ADDENDUM NO. 1

Gravesite Restoration at East Hawaii Veterans Cemetery No. 2, Hilo, Hawaii
State of Hawaii, Department of Defense, Office of Veterans Services
Job No. CA-202617-C, FAI No. HI-10-29

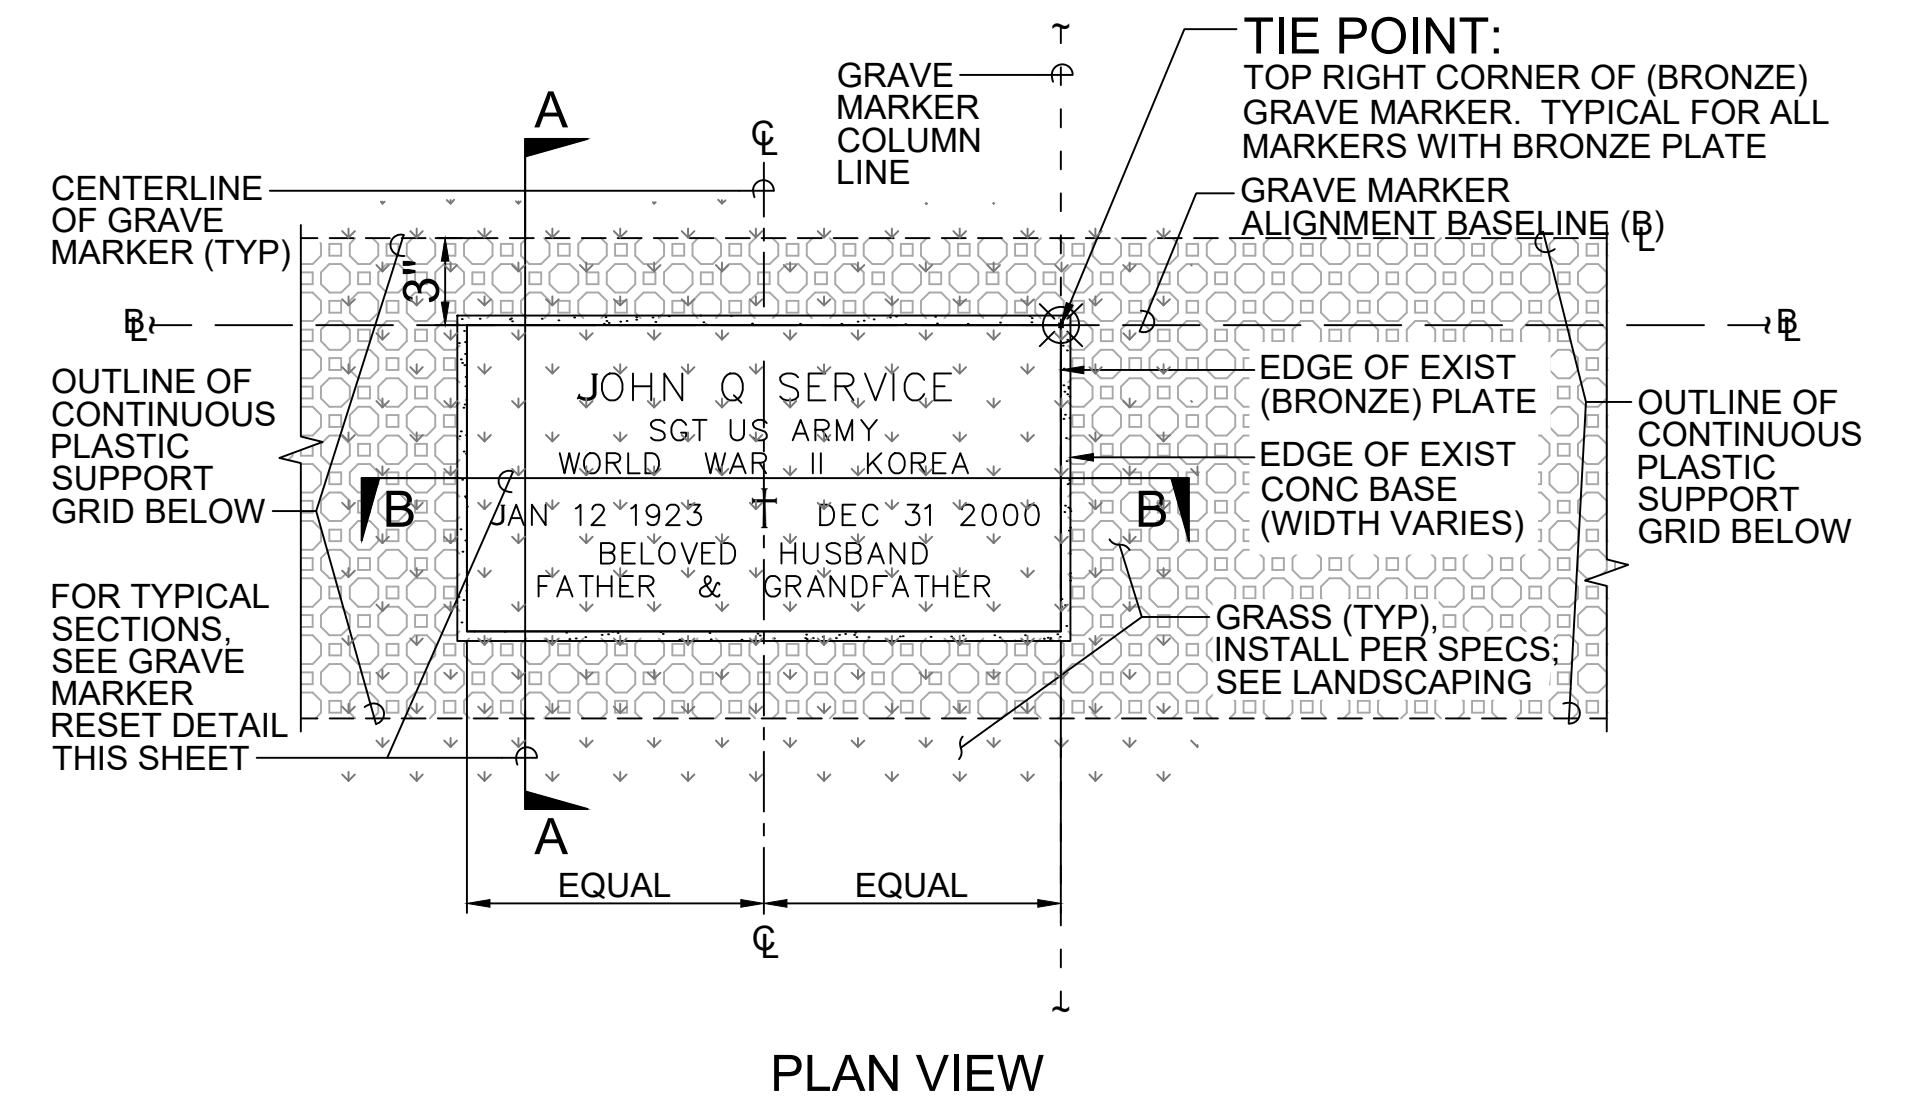
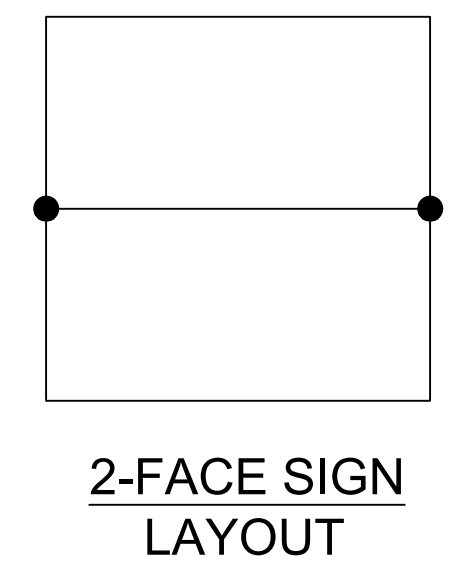
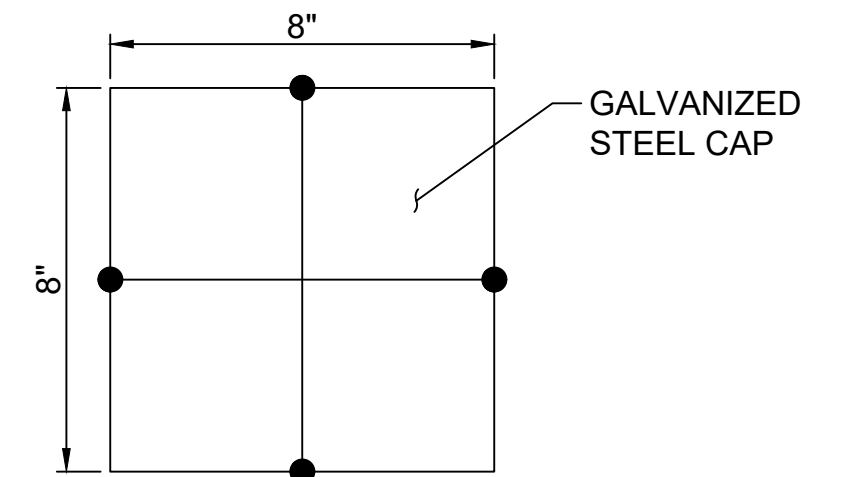
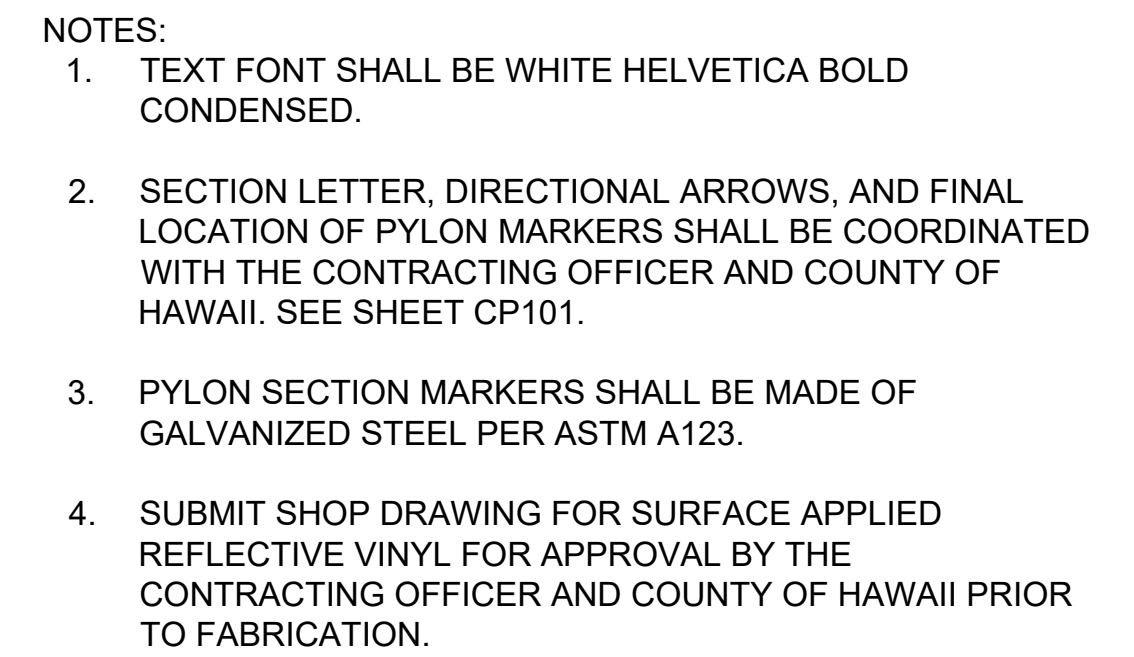
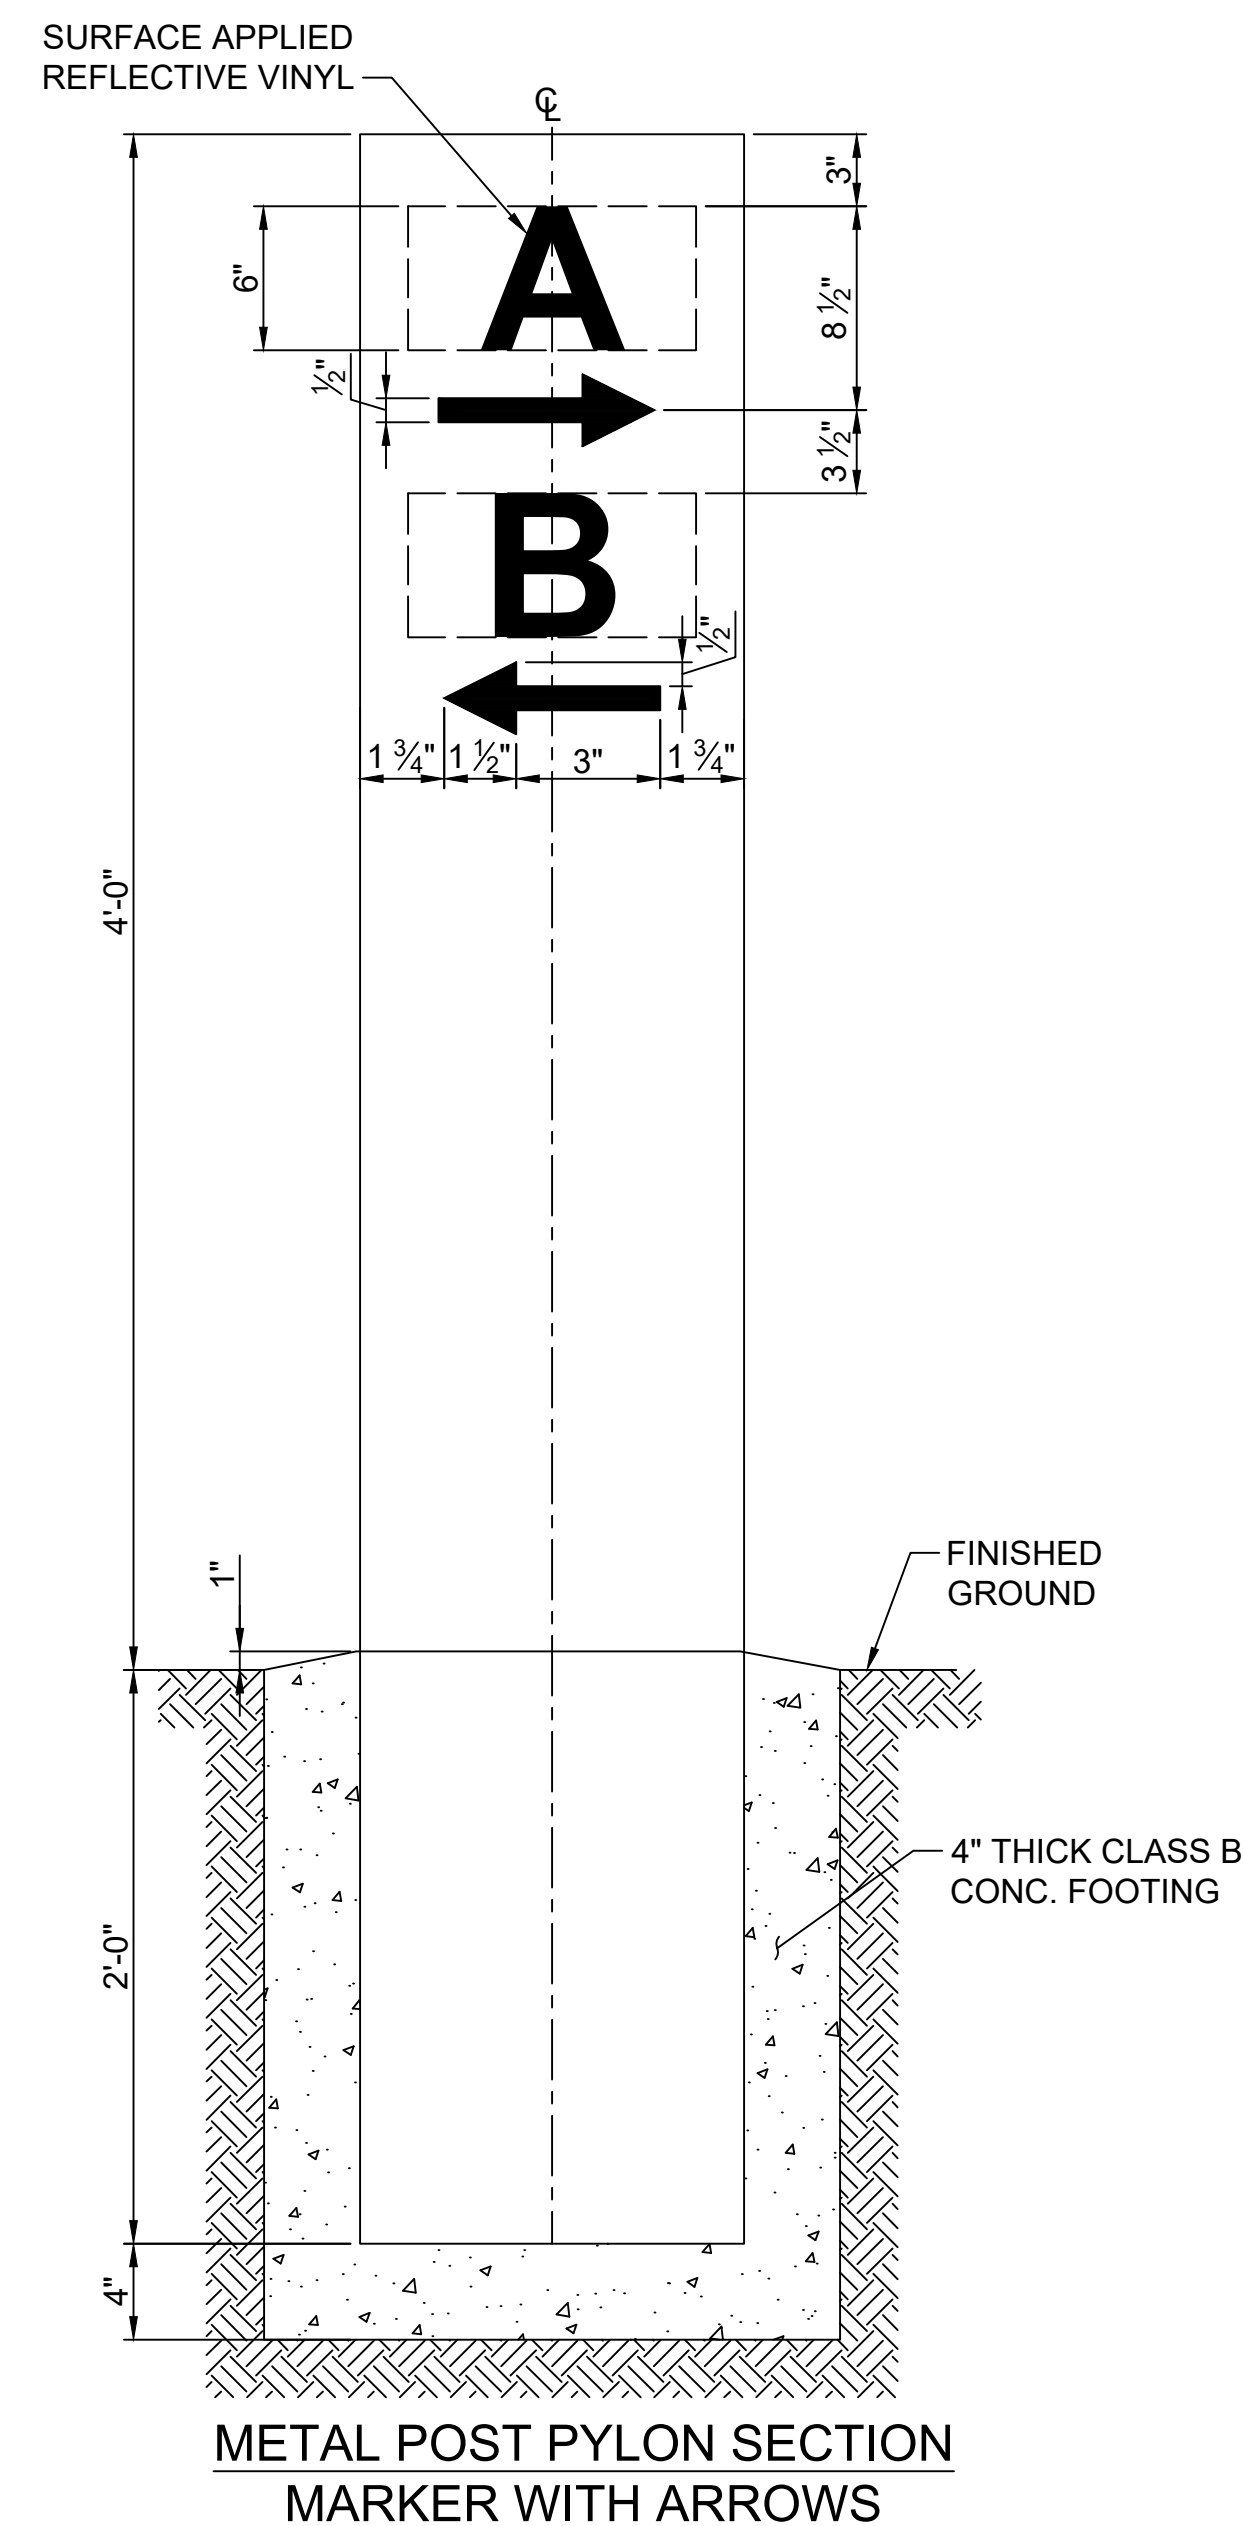
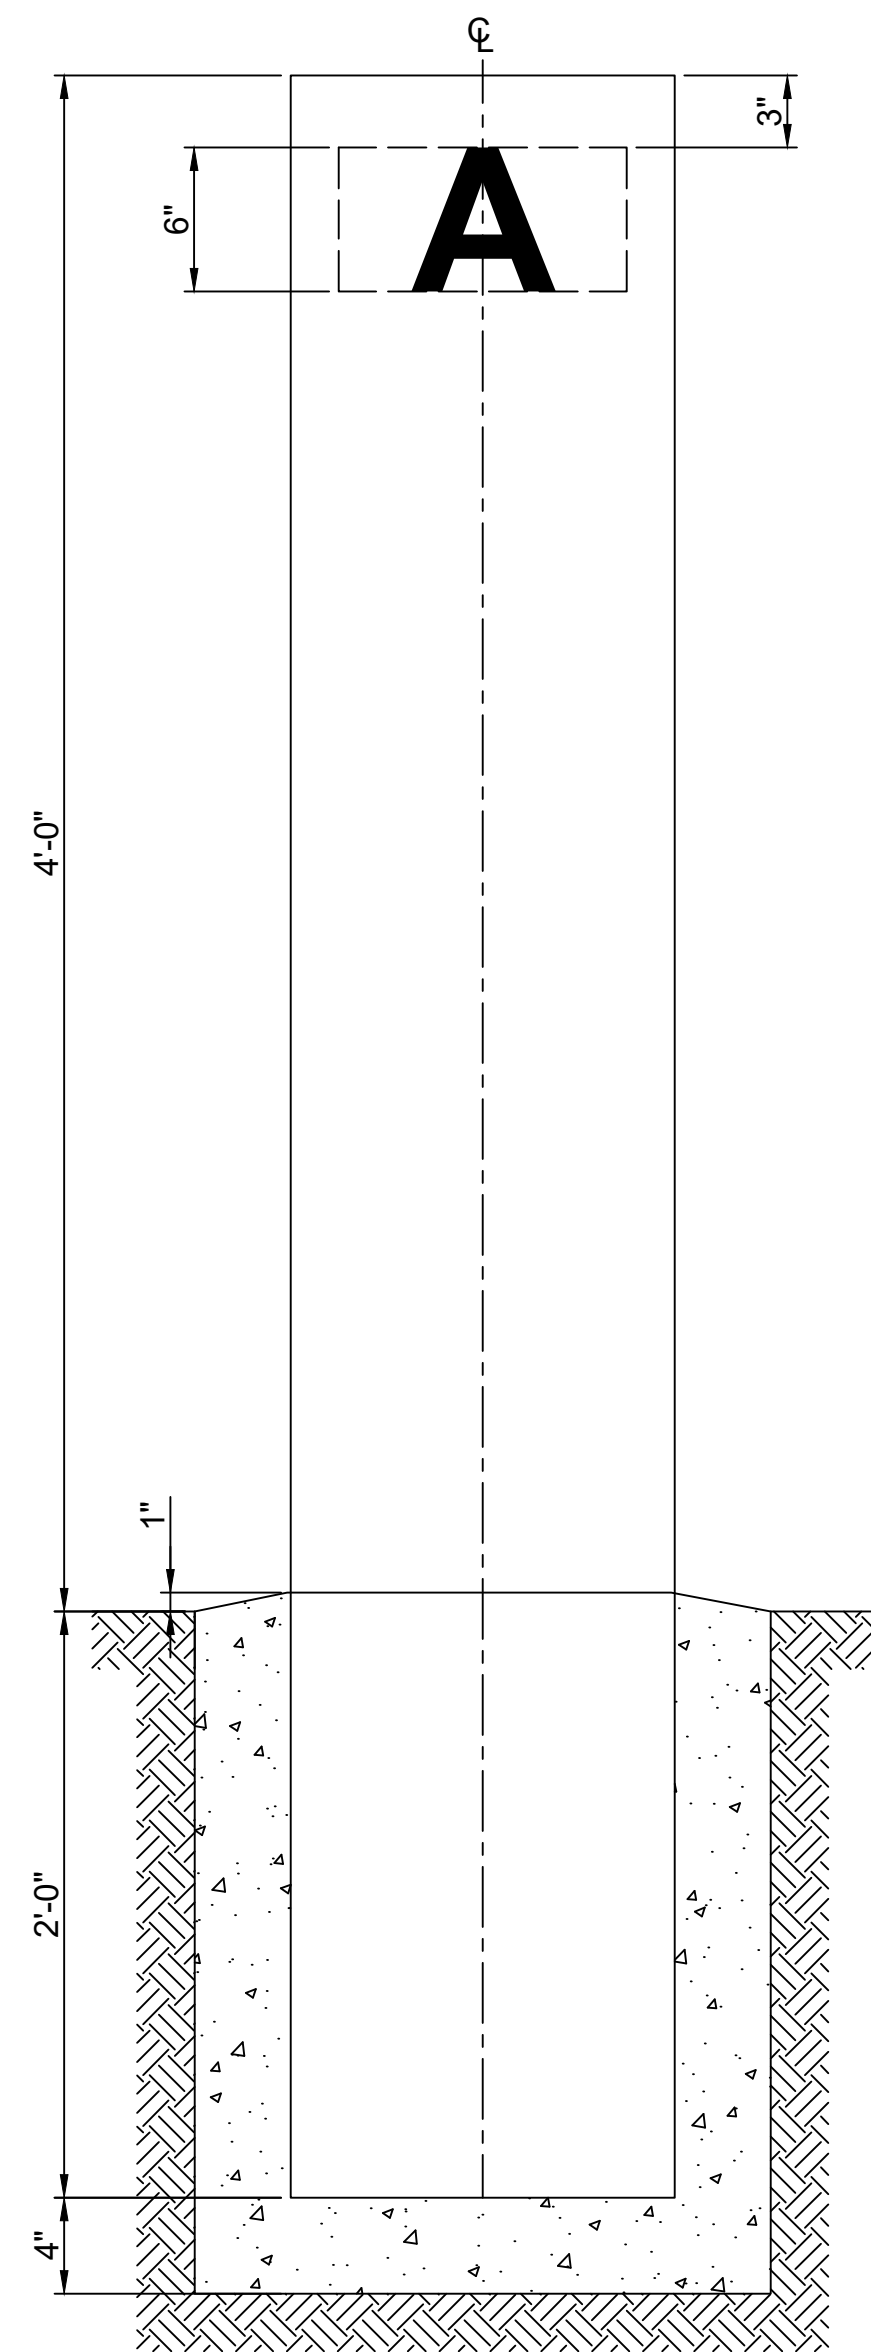
9. Please provide detail or product for temporary markers.

Response: See temporary marker below or use HIENG-DR approved equivalent.
